CALIFORNIA INSTITUTE OF TECHNOLOGY  
 MASSACHUSETTS INSTITUTE OF TECHNOLOGY

DCN No. E980249-00-D

## DOCUMENT CHANGE NOTICE (DCN)

DOCUMENT No. (DOC-REV-GP. ID)	TITLE	NEW REV.
D970550-A-D	Guide Rod Fixture, Beamsplitter Optics	B
D960147-B-D	Guide Rod Fixture	C

PROJECT NUMBER D970550	DATE 7/22/98	BY J. KIM	REV 1
LIGO CALIFORNIA INSTITUTE OF TECHNOLOGY MASSACHUSETTS INSTITUTE OF TECHNOLOGY		GUIDE ROD FIXTURE, BEAMSPLITTER OPTICS A	
D970550		REV 1 OF 3

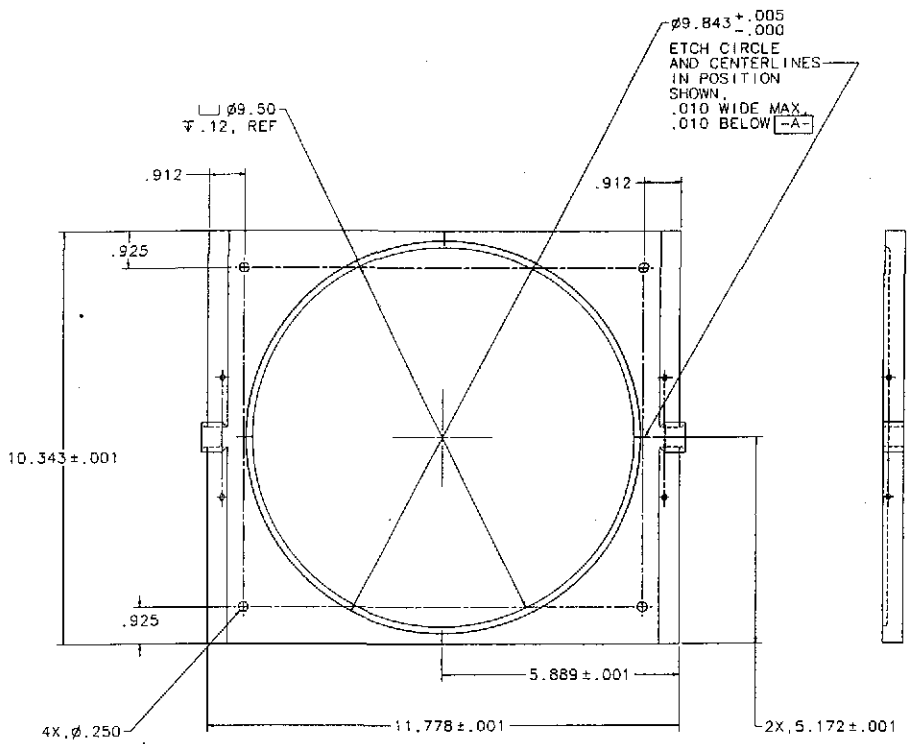
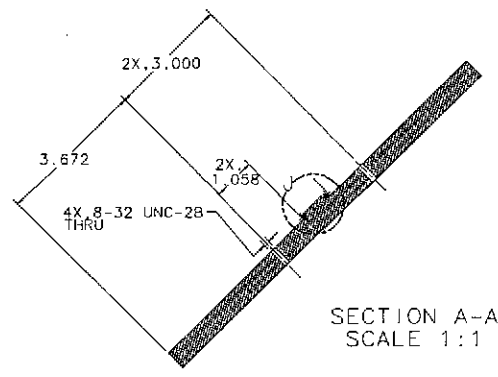
1. Add holes, like the ones on the fabricated D960147, for mounting a clamp fixture for the indium seals.
2. Document holes, for as-built configuration.

**REASON FOR CHANGE:** Continuity and document as-built configuration.
